NOTICE OF DECISION

CLASS 3 SITE PLAN REVIEW / CLASS 2 ADJUSTMENT CASE NO.: SPR-ADJ23-17

NOTICE OF DECISION DATE: June 29, 2023

SUMMARY: Proposed new 9,000 square-foot, two-story, office building with associated off-street parking and site improvements.

1 SITE PLAN
SCALE: 1"=20'-0"

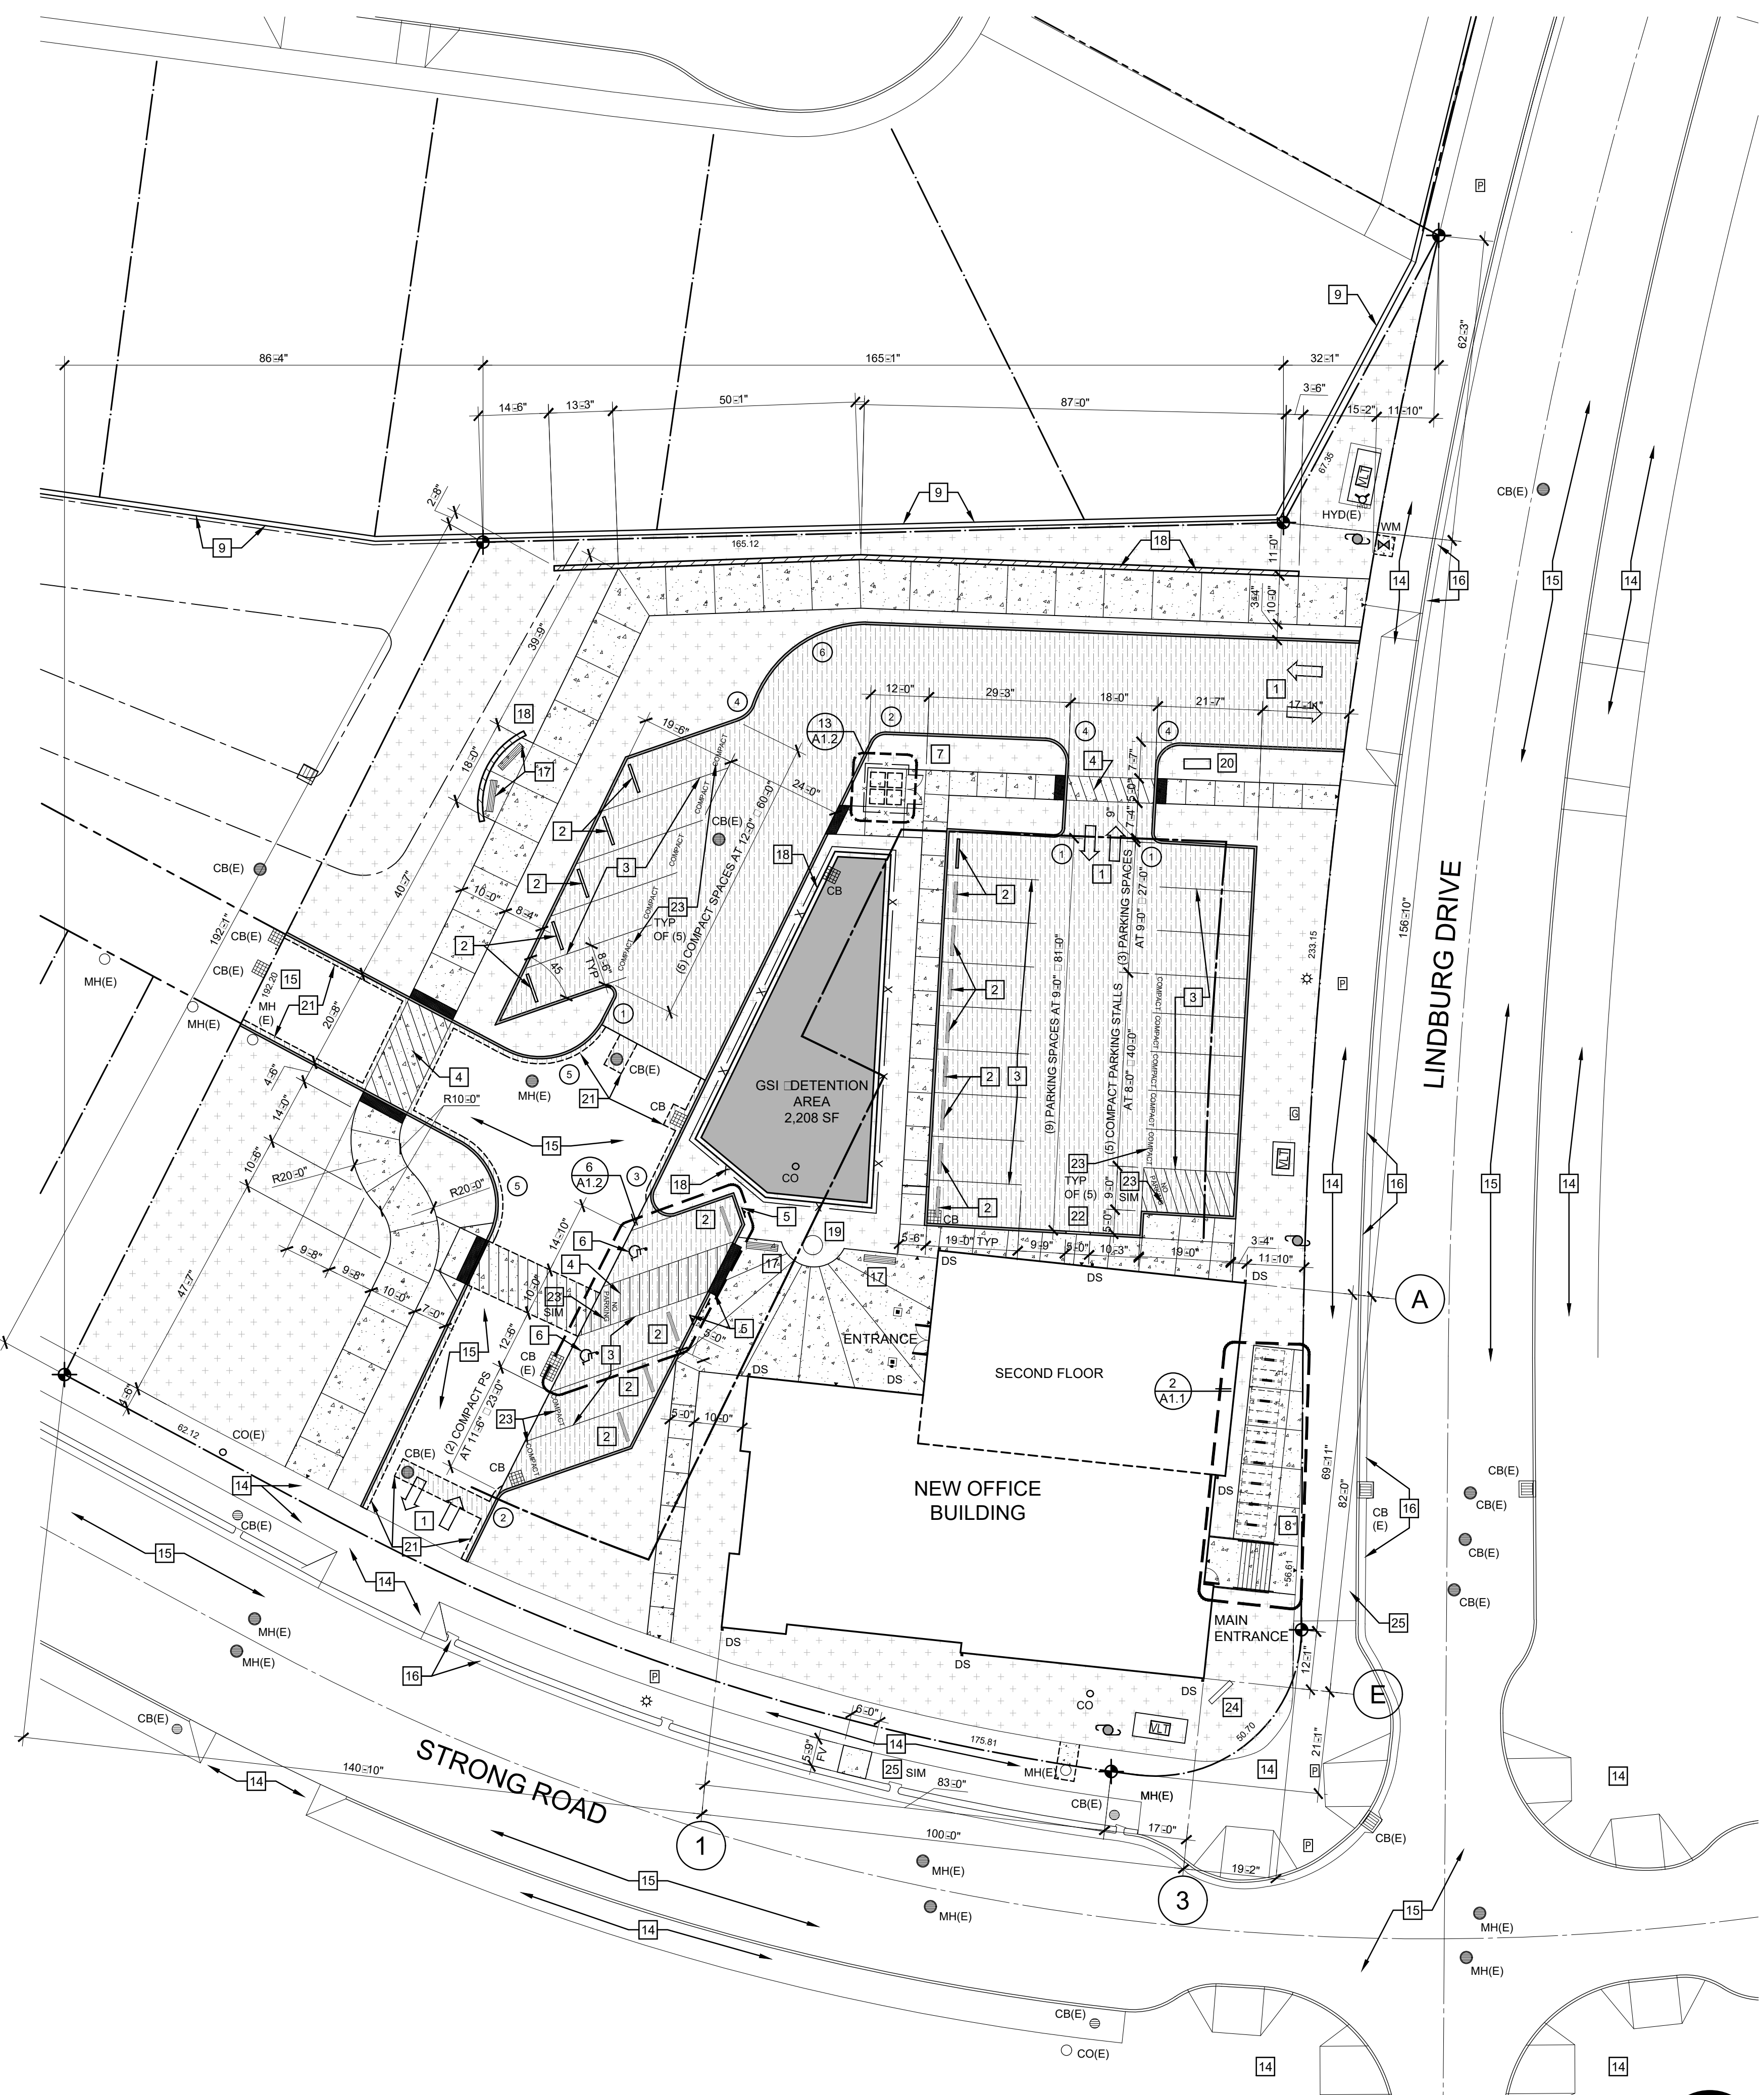
- 1) Maximum building setback abutting Strong Road. As shown on the site plan, the southeast corner of the proposed office building exceeds the maximum allowed 20-foot setback abutting Strong Road SE.

- 2) Minimum lot frontage abutting Strong Road and Lindburg Road. As shown on the site plan, the proposed development does not include a minimum of 70 percent of the lot frontage of Lindburg Road SE and Strong Road SE with buildings placed at the minimum setback line.

- 3) Maximum side street building setback abutting private internal street. As shown on the site plan, the proposed office building exceeds the maximum allowed 20-foot setback from the proposed internal private street.

- 4) Minimum parking setback abutting street. As shown on the site plan, the proposed off-street parking area located to the north of the office building does not meet the minimum required 20-foot setback abutting Lindburg Road SE and the proposed private internal street.

As shown on the site plan, the off-street parking area to the north of the proposed building terminates in a dead-end and a turnaround area is provided, but the turnaround is configured in a manner that does not conform to the configuration required under Figure 806-9 to ensure that a vehicle parking in the space located at the southwest corner of the parking lot has area to turnaround when exiting the space. In order to ensure that the vehicle maneuvering and turnaround requirements of SRC 806.035(f) are met, the following condition of approval shall apply:

As shown on the site plan (**Attachment B**), a portion of the southeast corner of the proposed building adjacent to the intersection of Strong Road and Lindburg Road slightly exceeds the maximum allowed 20-foot setback abutting Strong Road. Rather than being setback no further than 20 feet from the street, this portion of the building is setback approximately 21.5 feet. A minimum of 70 percent of the lot frontages of the site abutting Strong and Lindburg Road are also not occupied by buildings placed at the minimum setback line.

Condition 1: The off-street parking area to the north of the proposed building shall be configured to meet the maneuvering and turnaround requirements of SRC 806.035(f)(2).

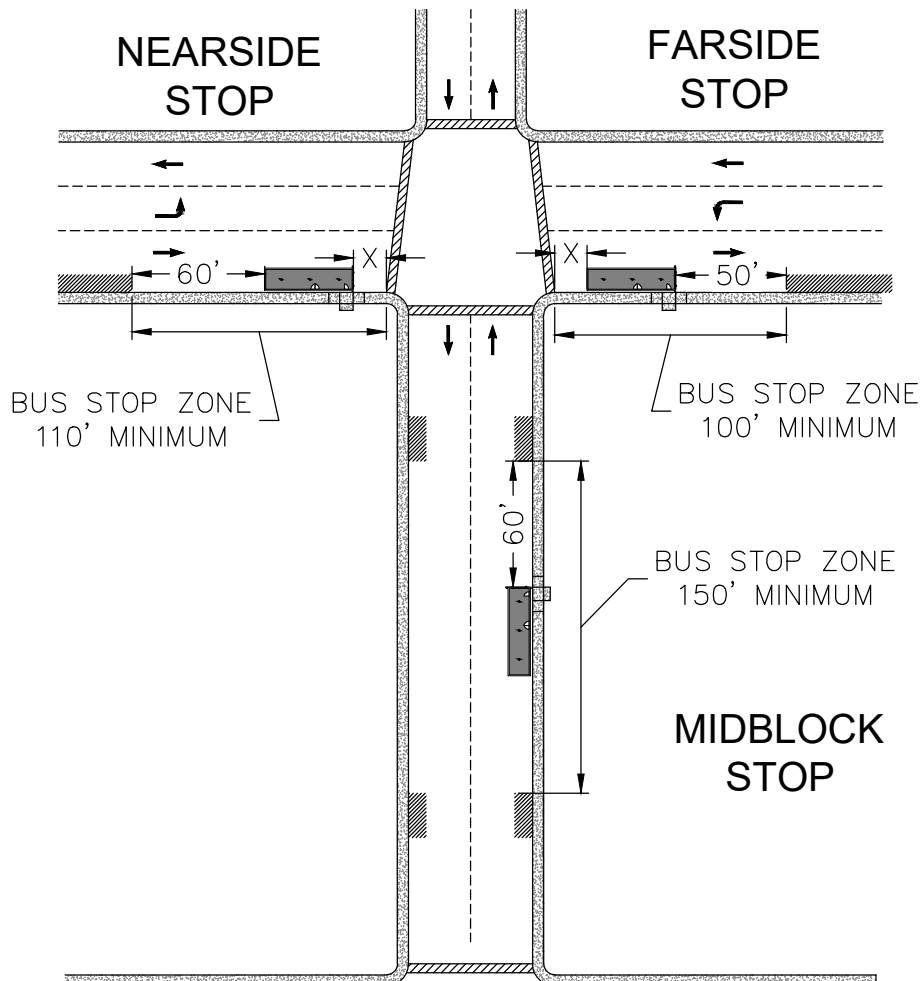
COMMENTS: A transit stop has been identified as needed in connection with this proposed development. Cherriots requests a transit stop conforming to the applicable standards of the Salem Area Mass Transit District to be constructed and right-of-way dedication, if necessary, to be provided as part of this development. On-street parking shall be restricted in the area of the transit stop in order to ensure unobstructed access by transit. The minimum bus stop zone required is 100 feet as shown in the attached drawing - No Parking Zones at Intersections Detail (C8). The type, size, and location of the transit stop shall be as depicted in Reference Note 25 on Sheet A1.1 of the Site Plan included in the Notice of Filing distributed on May 22, 2023 (see screenshots on following page). AC+CO Architecture Community was provided with examples of swale bridges in an email from Cherriots staff on February 16, 2023 (also attached). Cherriots requests that final design of the transit stop be submitted to Cherriots staff at planning@cherriots.org for approval prior to construction.

- Condition 2:** The applicant shall coordinate with Cherriots to locate and construct a transit stop conforming to applicable Salem Area Mass Transit District Standards and the Public Works Design Standards (PWDS) on Strong Road SE.
